SERVICE LETTER NUMBER 98			
MAIN GEAR RAM INSPECTION AND IMPROVEMENT			
BY: MAS	AIRCRAFT MAKE/MODEL(S): DeHavilland DHC-2, DHC-6 Cessna 208, Air Tractor AT-802, AT-802A	FLOAT MODEL(S): ALL AMPHIBIOUS 6100, 8000, 10000, 13000	NOTE(S): MANDATORY P/N 1002759
APP: DRH			
DATE: 8/9/2022			
REV: C

FIGURE 2

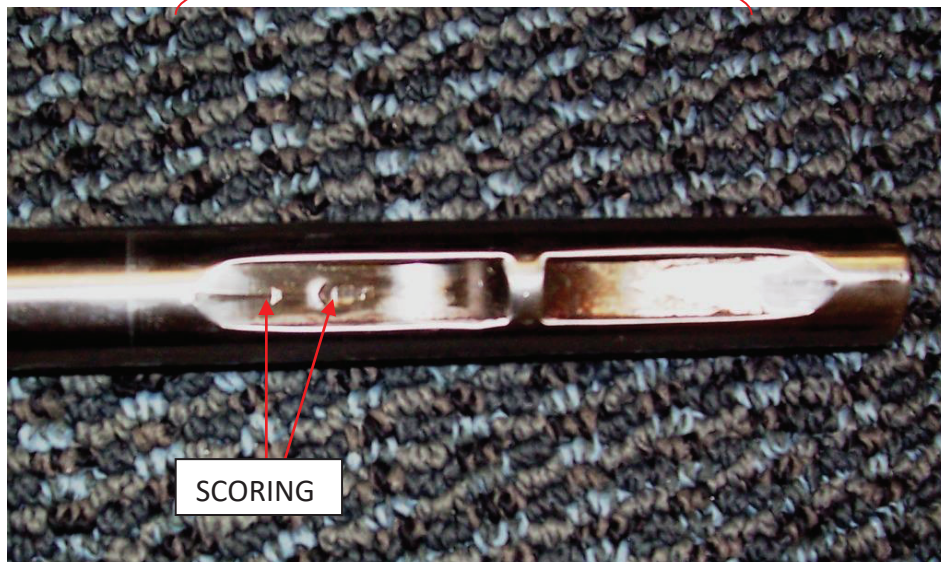
COMPLIANCE METHOD: The main gear actuating ram needs to be inspected under the trolley gear lock. If there is uneven wear or pocketing from the set screw on the ram, as in Figure 2, the rod must be polished smooth or replaced. We authorize and encourage customers to polish the ram when possible. The set screws must be replaced if they have a dimple in the end as they have been improved by removing the machined dimple and polishing

3. Inspect ram depressions for wear. It will likely appear as scoring; this is from the set screws applying pressure as they slide past the depressions onto the body of the ram. The wear must be smooth without gouging or scoring.
4. If there is no wear, or the wear is smooth and even, fill the depressions with grease, install new set screws that have the smooth ends and put everything back together.

5. If there is uneven wear on the ram, it will have to be polished smooth or replaced.
6. When parts are received, put back together and fill ram depressions with grease before final assembly.
7. When this Service Letter has been complied with, make an entry in the logbook as to its completion and whether or not the ram and set screws were replaced

FIGURE 3

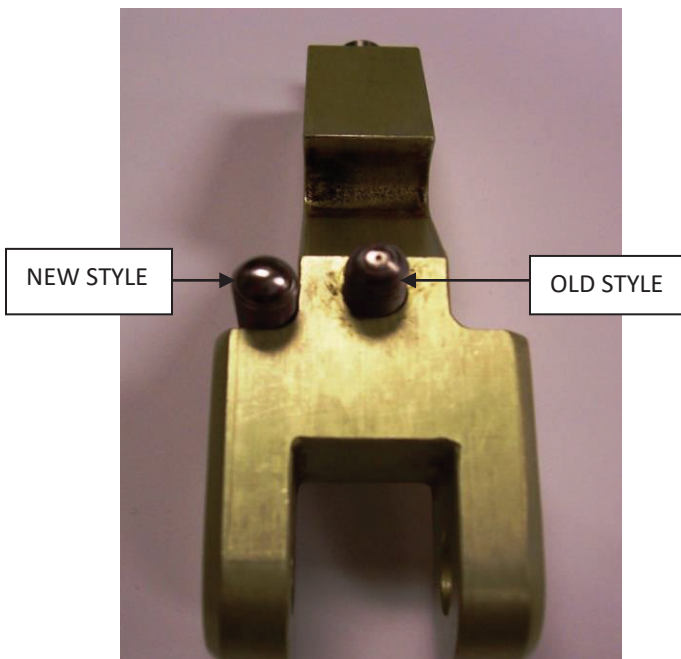
8. The product improvement part of this Service Letter is that the set screw is now manufactured so that there is no indent at the tip. Figure 3 illustrates the difference
